**BOULDER COUNTY
BOARD OF COUNTY COMMISSIONERS
PUBLIC HEARING**

SPR-23-0108: Piscopio-Huang Residential Remodel and New Accessory Structure

Staff recommends that the Board of County Commissioners uphold the Director’s Determination for SPR-23-0108, Piscopio-Huang Residential Remodel and New Accessory Structure.

2 Upper Floor Plan
1/4" = 1'-0"

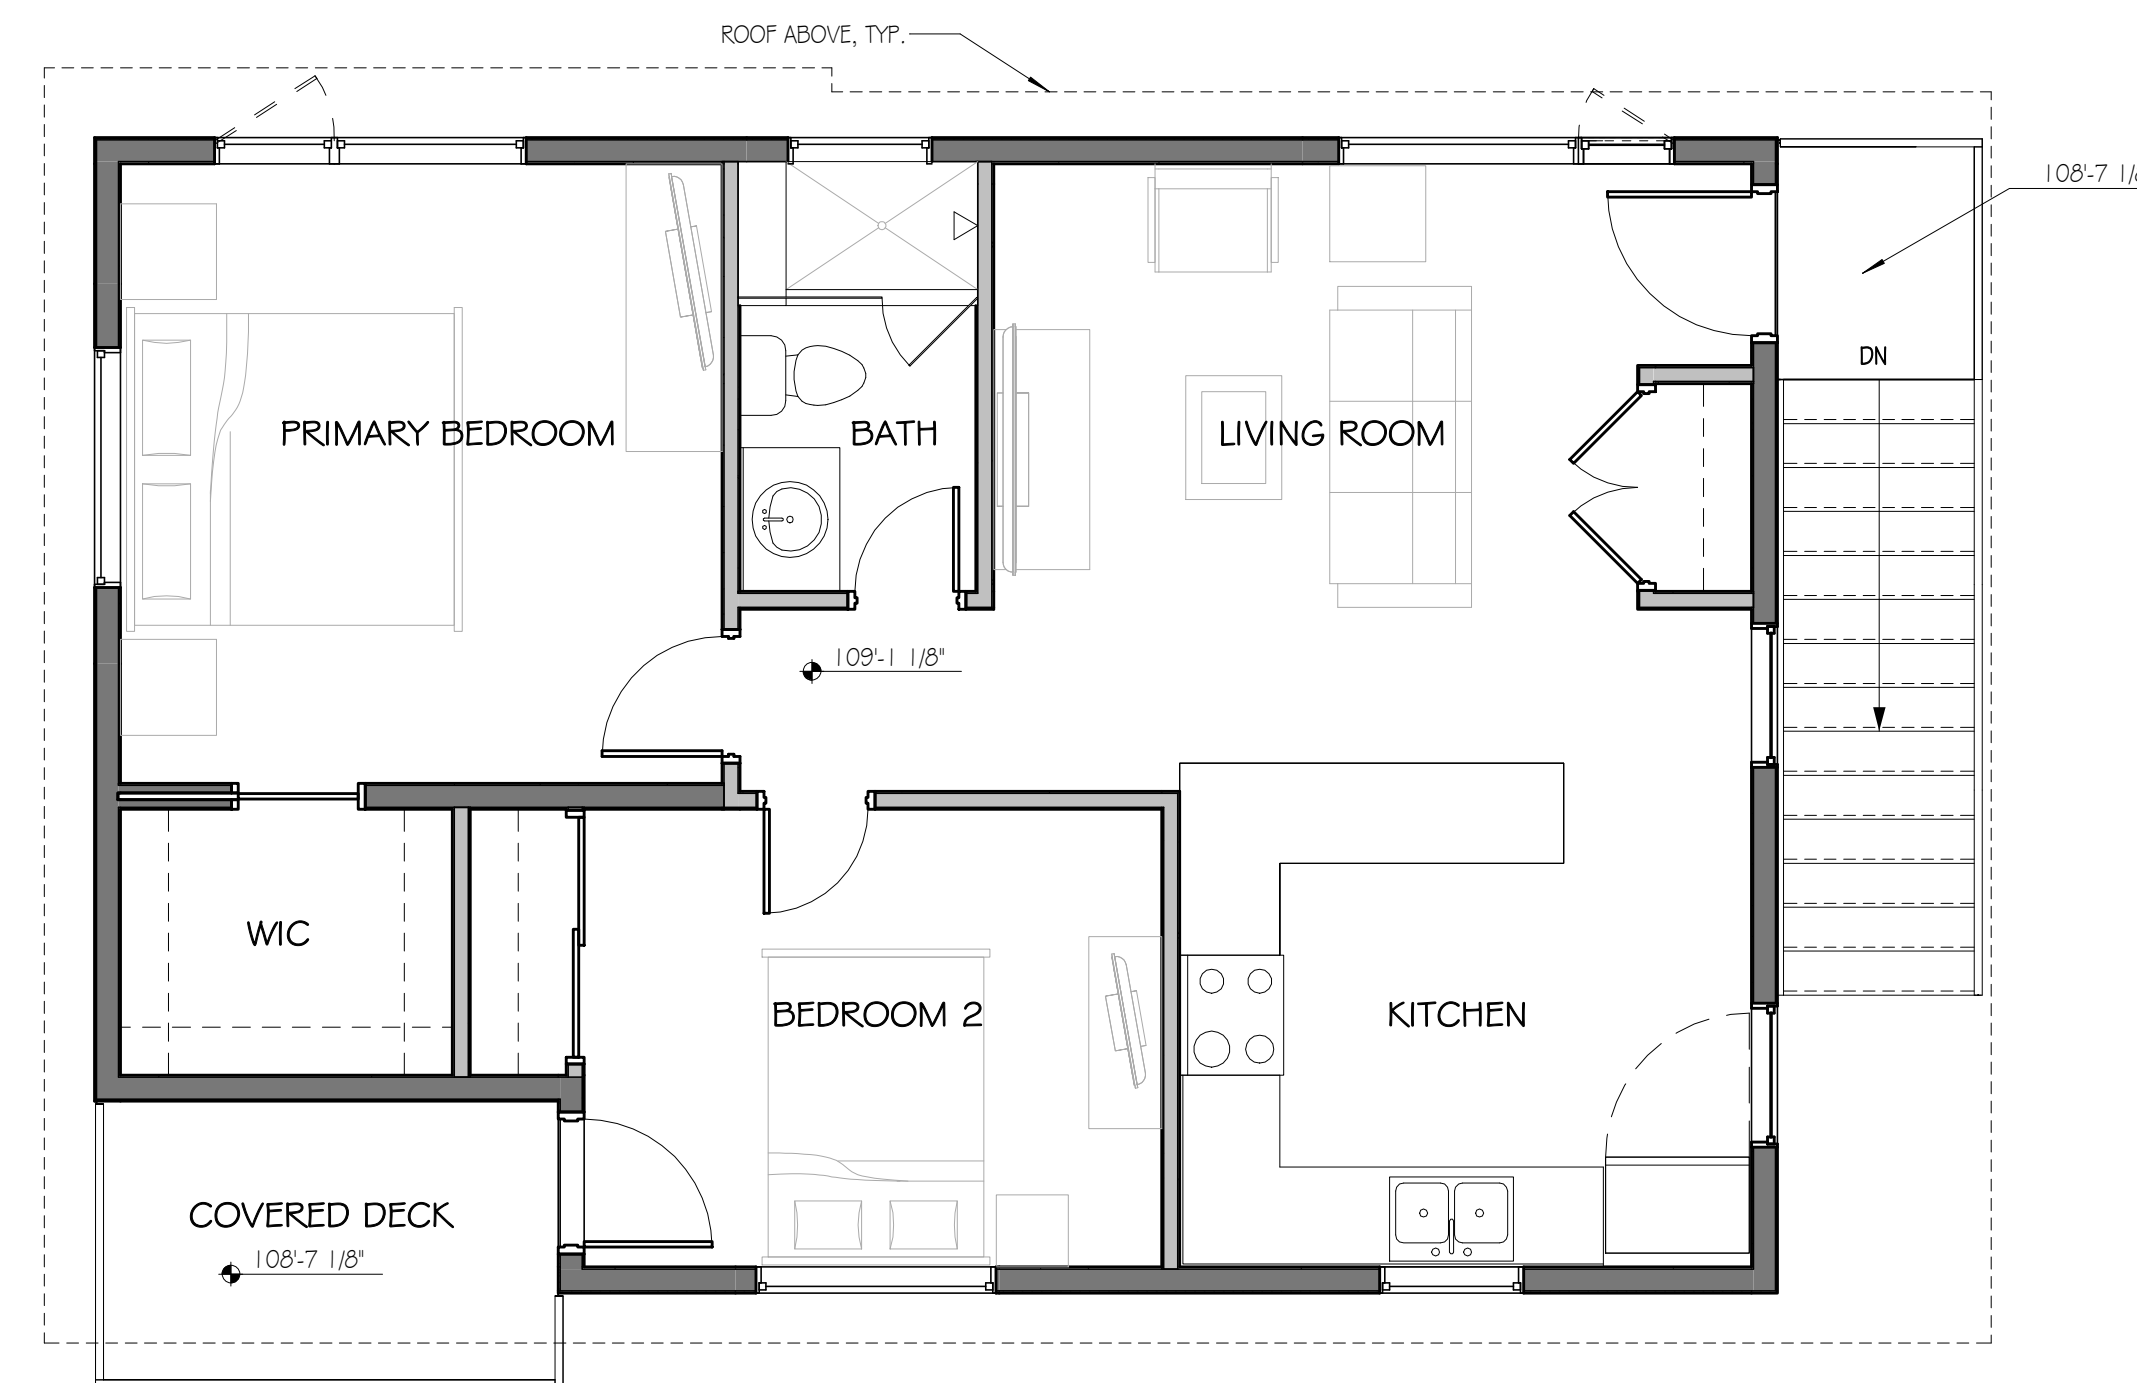
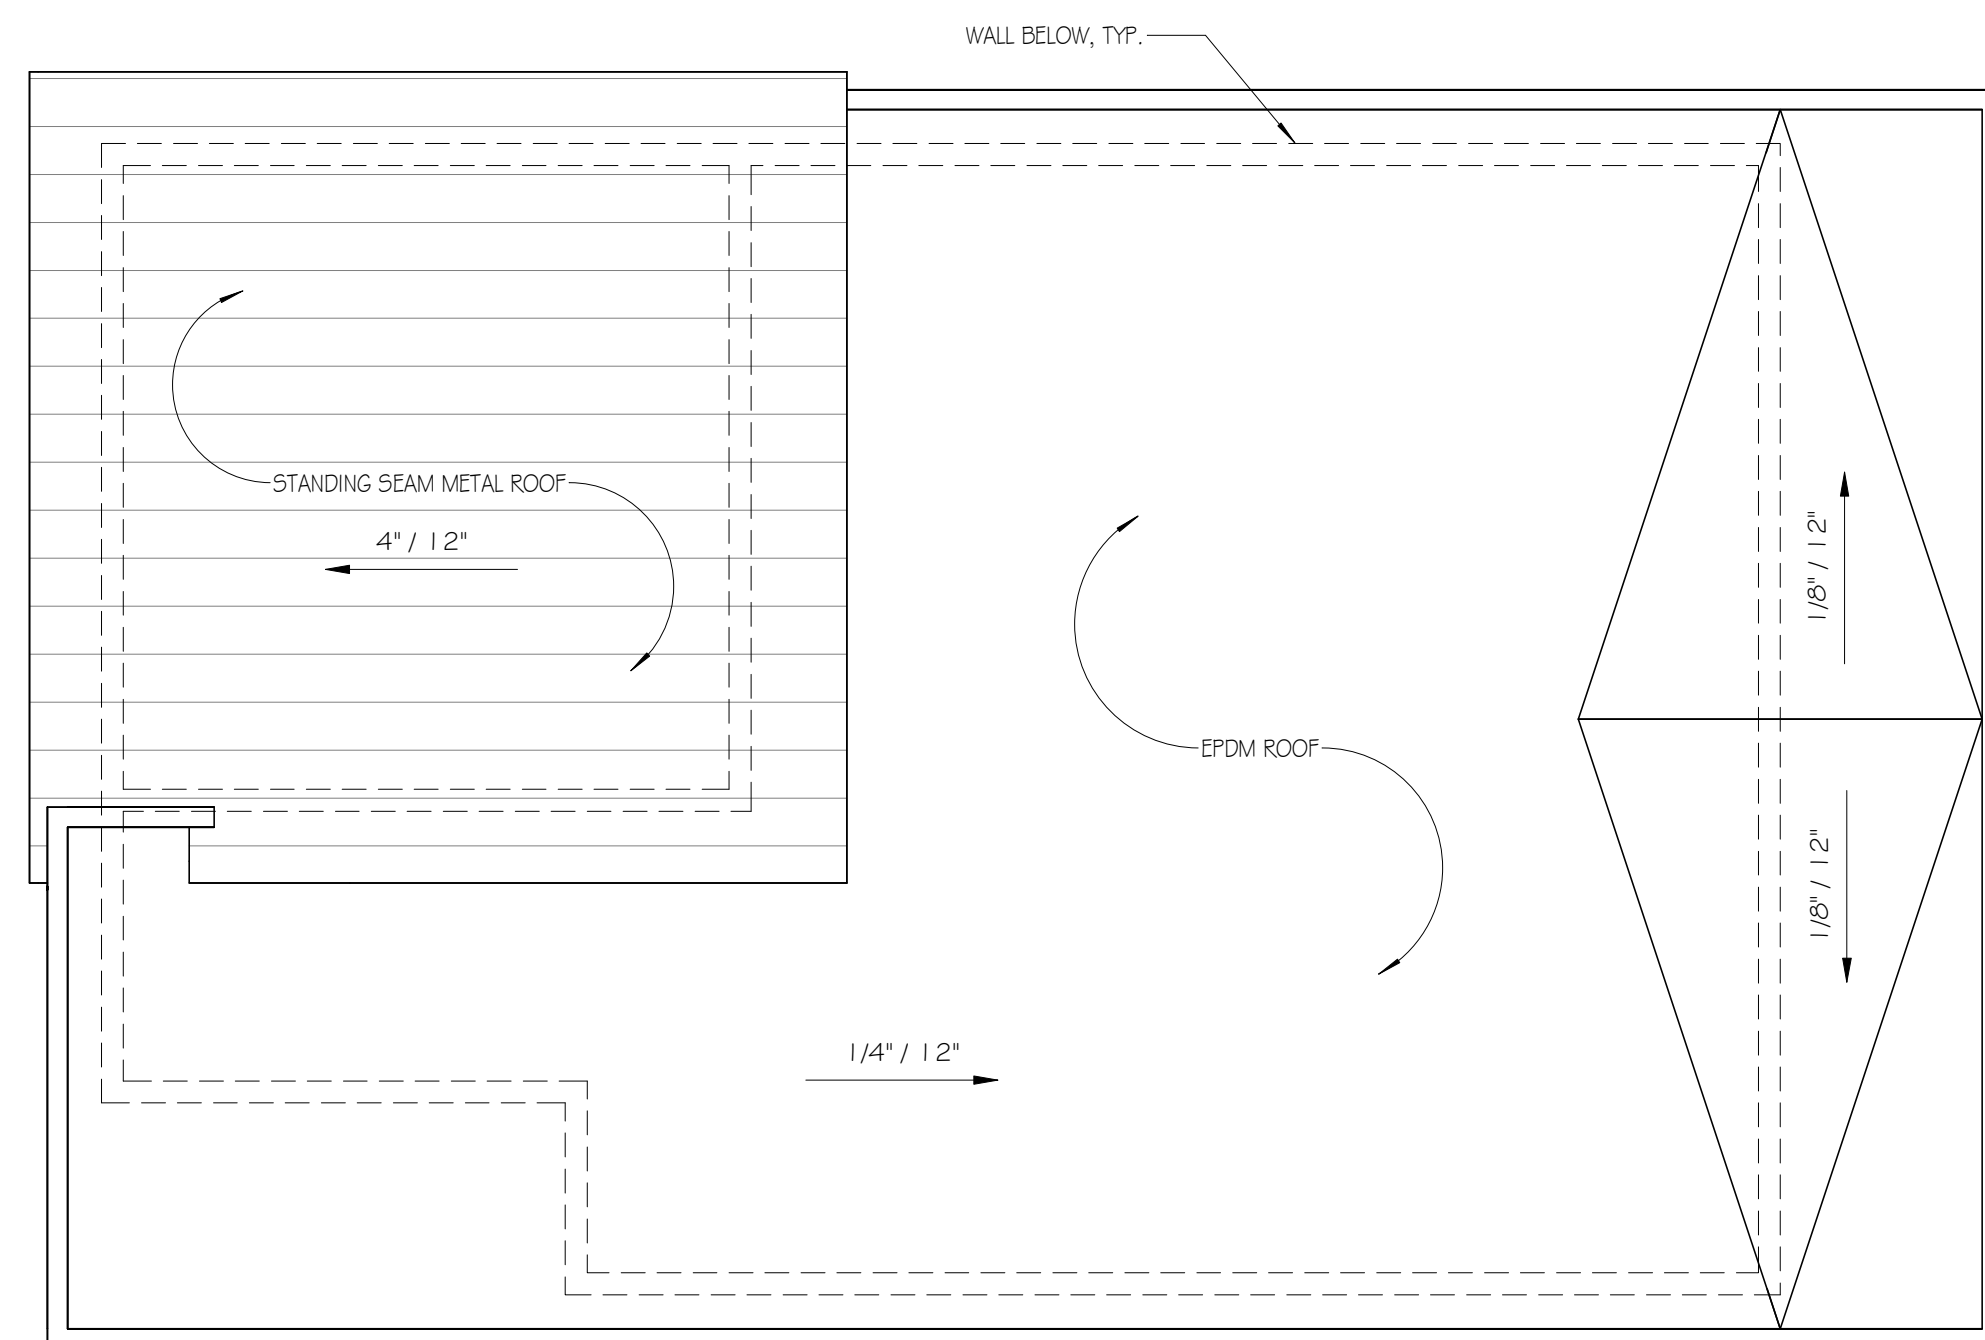
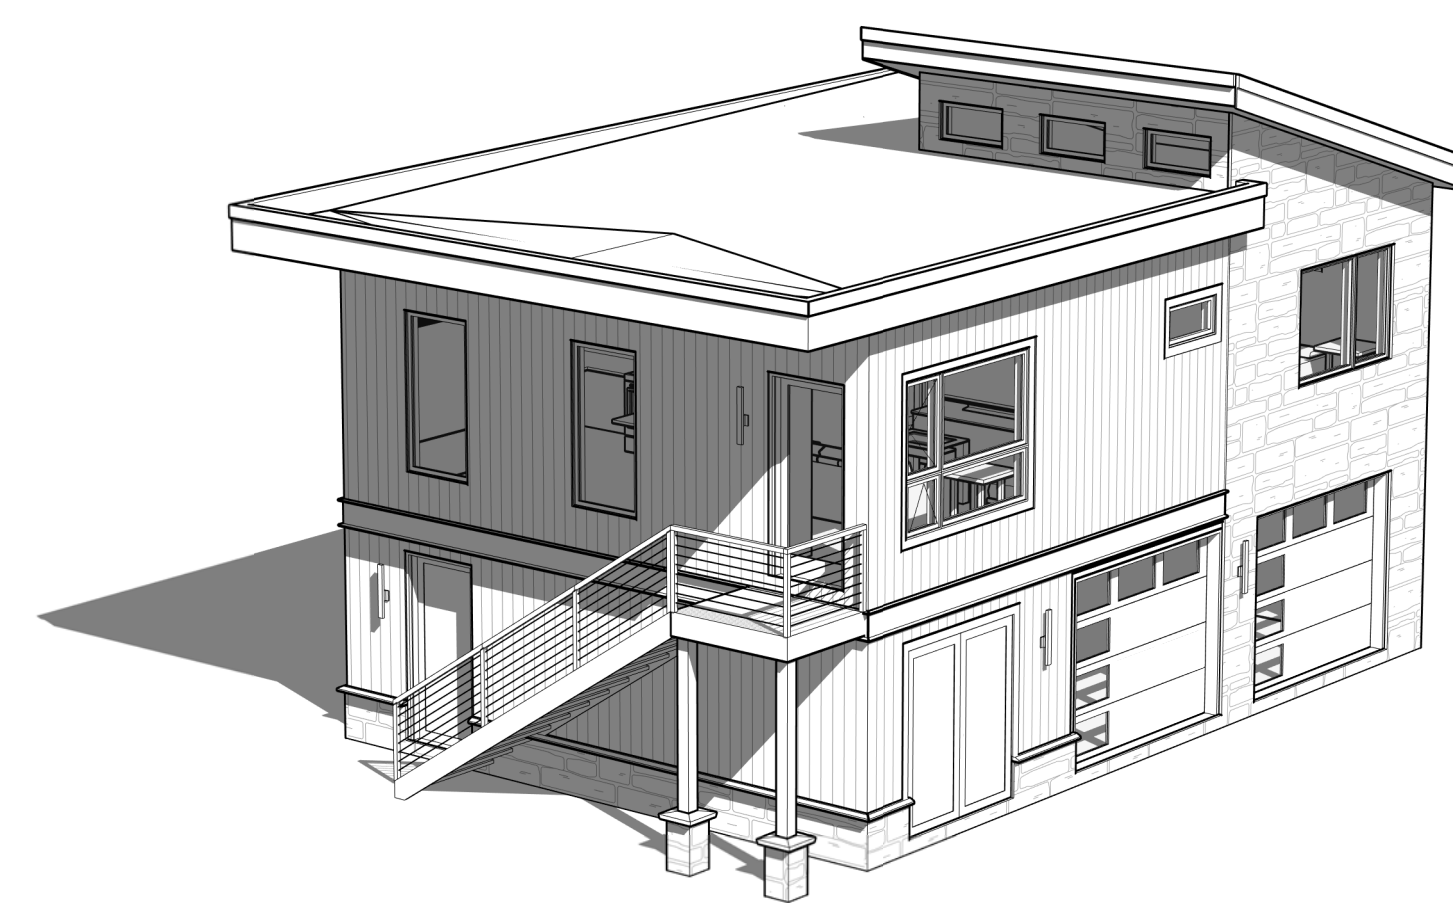
The location of the residential remodel shown on the site plan dated November 13, 2023 and identified in the field is approved as proposed. The location of the accessory structure is not approved.

NOT APPROVED

3 South Exterior Elevation
1/4" = 1'-0"

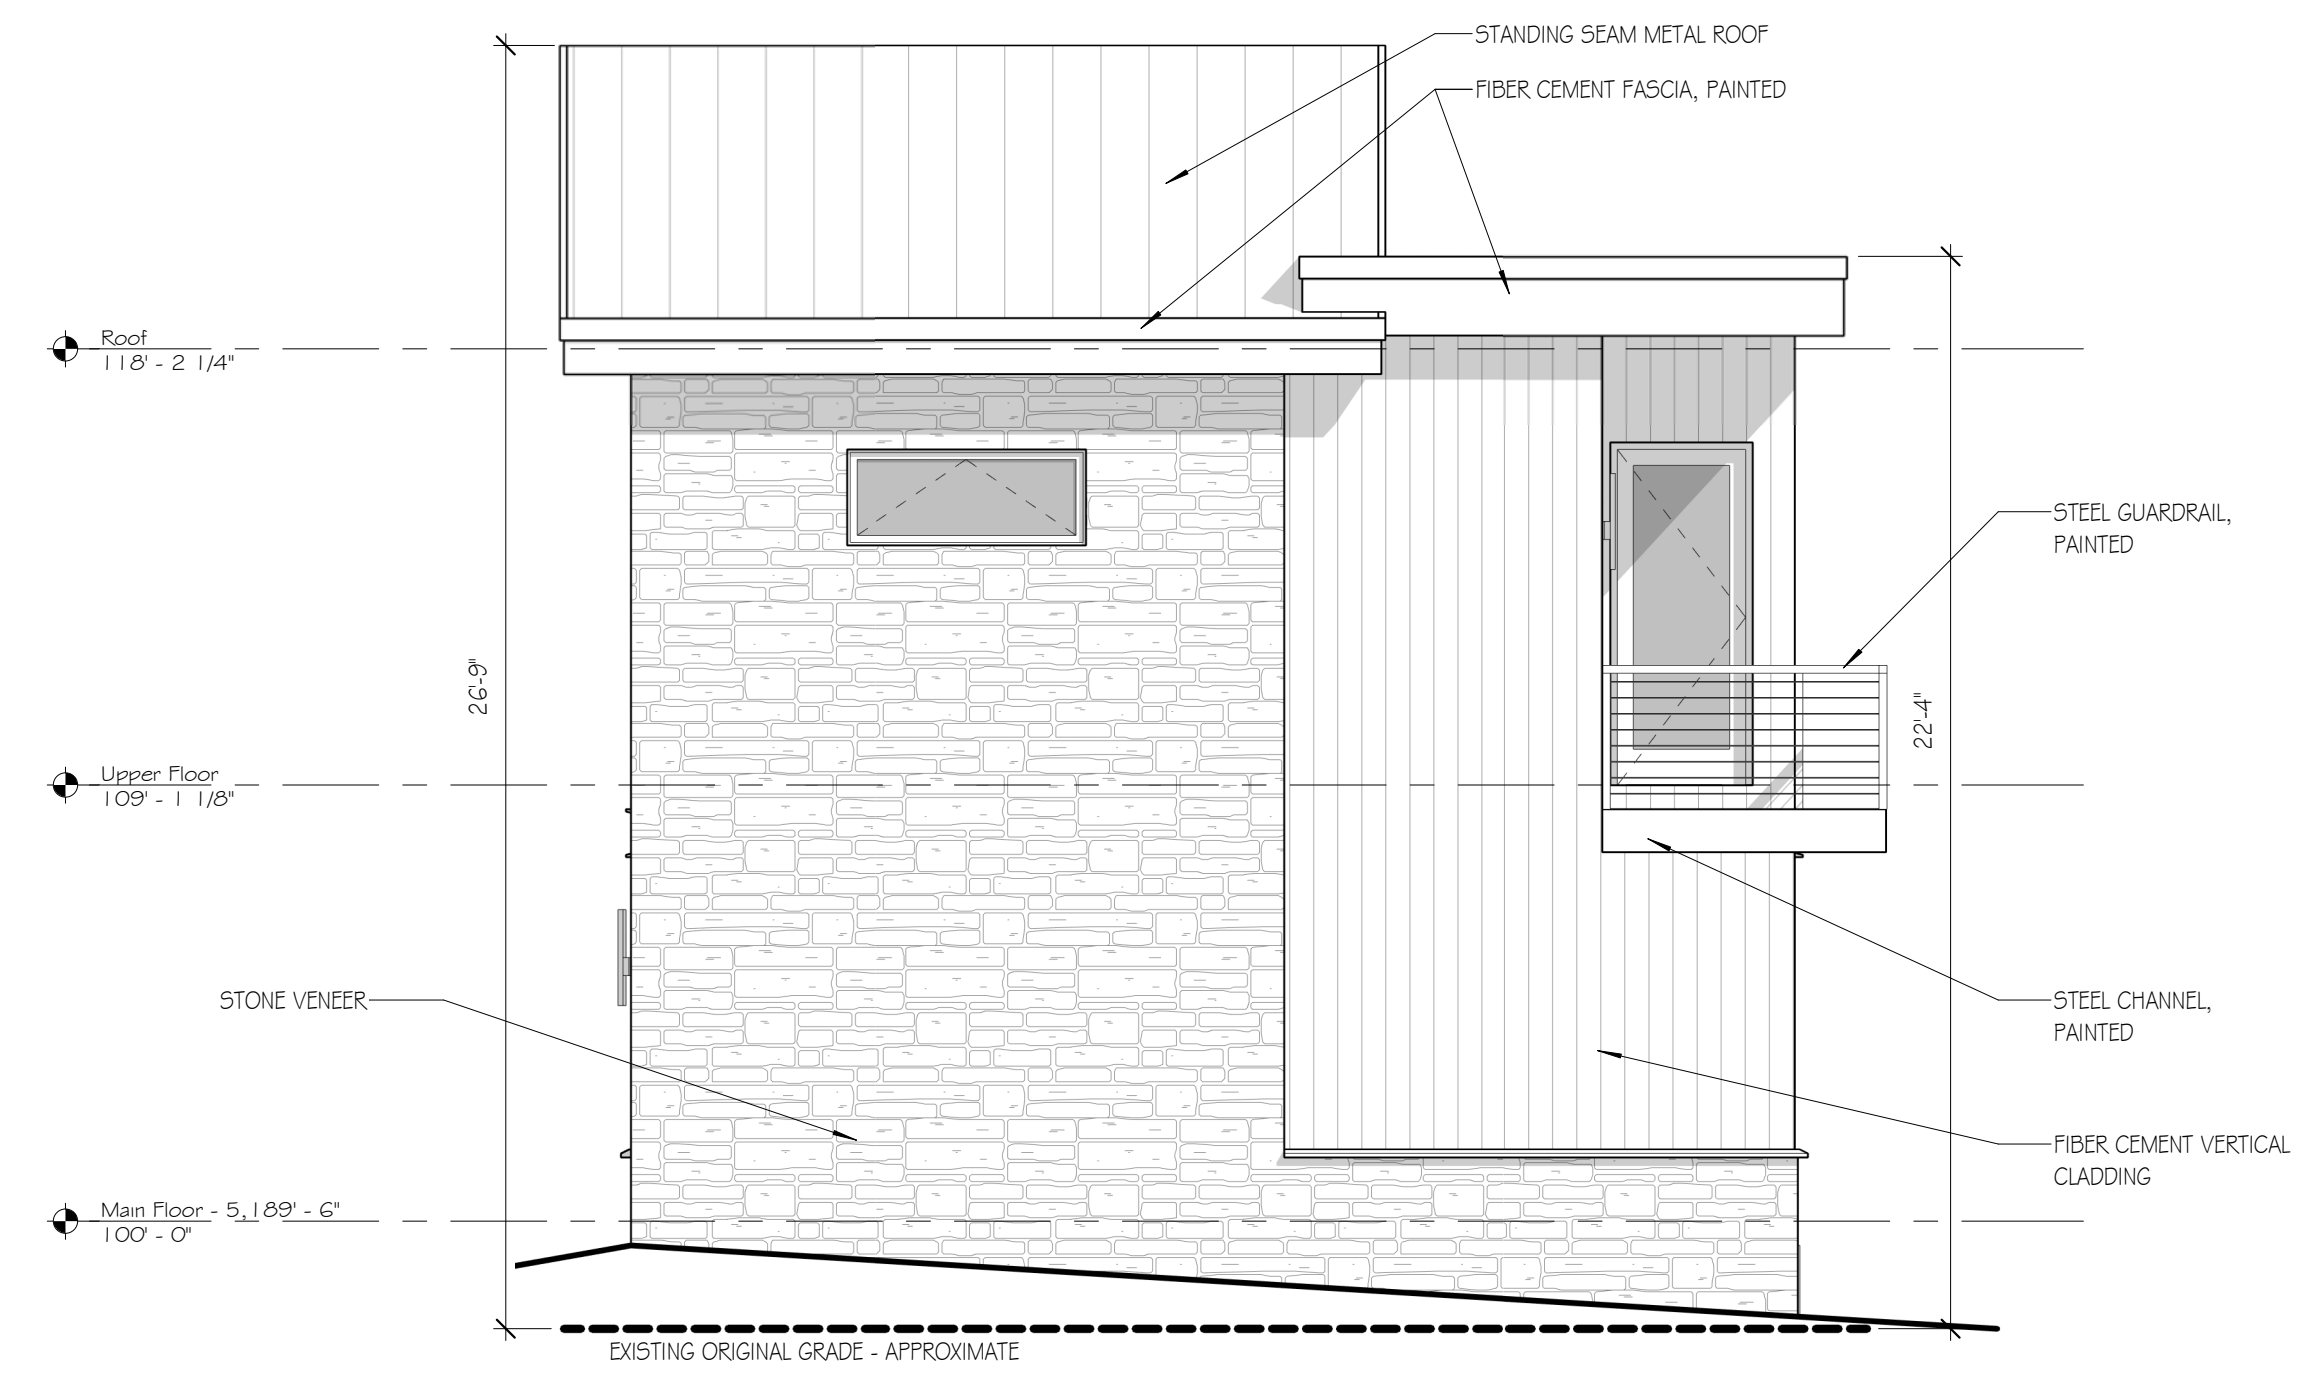
The submitted narrative dated November 13, 2023 that was included with application materials states that the existing basement will be converted to crawlspace. However, the elevations and floor plans dated November 13, 2023 include existing windows to remain on the south elevation at the basement level. To comply with the Building Code, windows are not permitted in a crawlspace.

At time of building permit, submit revised elevations reflecting removal of the basement level glazing on the south-facing façade for review and approval by Community Planning & Permitting Staff.
